Technical Service Bulletin

SUBJECT:		No: TSB-17-32-001	
TORQUE UPDATES: STEERING GEAR & LINKAGE – SERVICE MANUAL REVISION		DATE: January, 2017	
		MODEL: 2014–16 Outlander, 2011–16 Outlander Sport/RVR	
CIRCULATE TO:	<input type="checkbox"/> GENERAL MANAGER	<input checked="" type="checkbox"/> PARTS MANAGER	<input checked="" type="checkbox"/> TECHNICIAN
<input checked="" type="checkbox"/> SERVICE ADVISOR	<input checked="" type="checkbox"/> SERVICE MANAGER	<input type="checkbox"/> WARRANTY PROCESSOR	<input type="checkbox"/> SALES MANAGER

This TSB updates the Power Plant Mount section of the affected Service Manuals to correct the clamping torque of steering gear and linkage in front crossmember removal and installation.

ACD00212AC

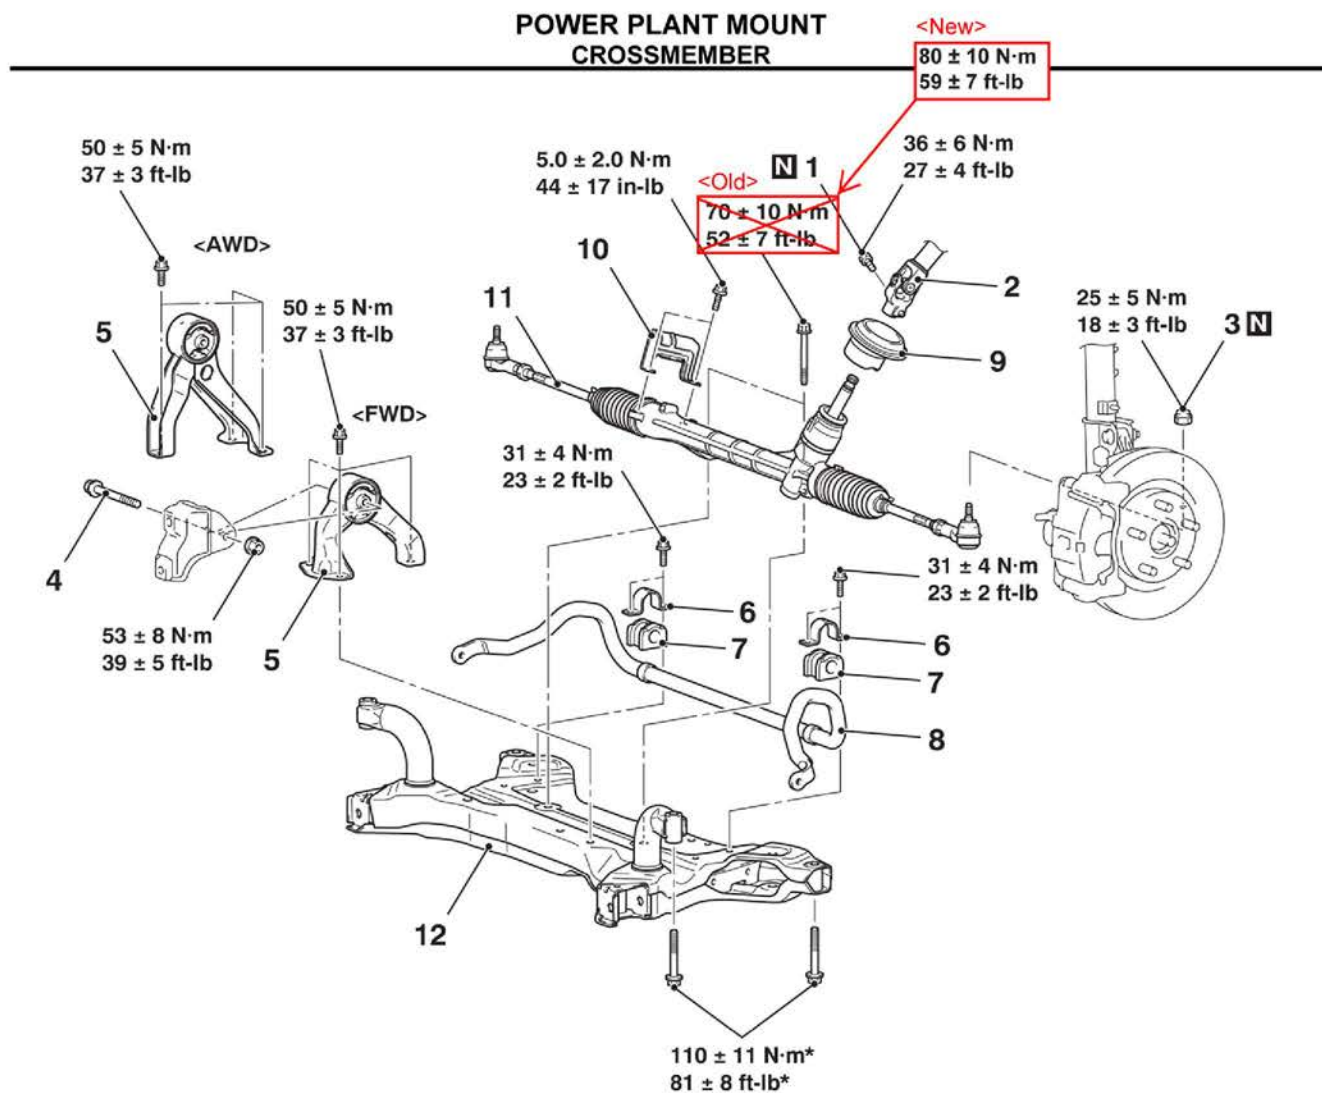
Please make the indicated changes to the 2014 – 2016 Outlander Service Manual, Group 32 – Power Plant Mount –> Crossmember –> Removal and Installation.
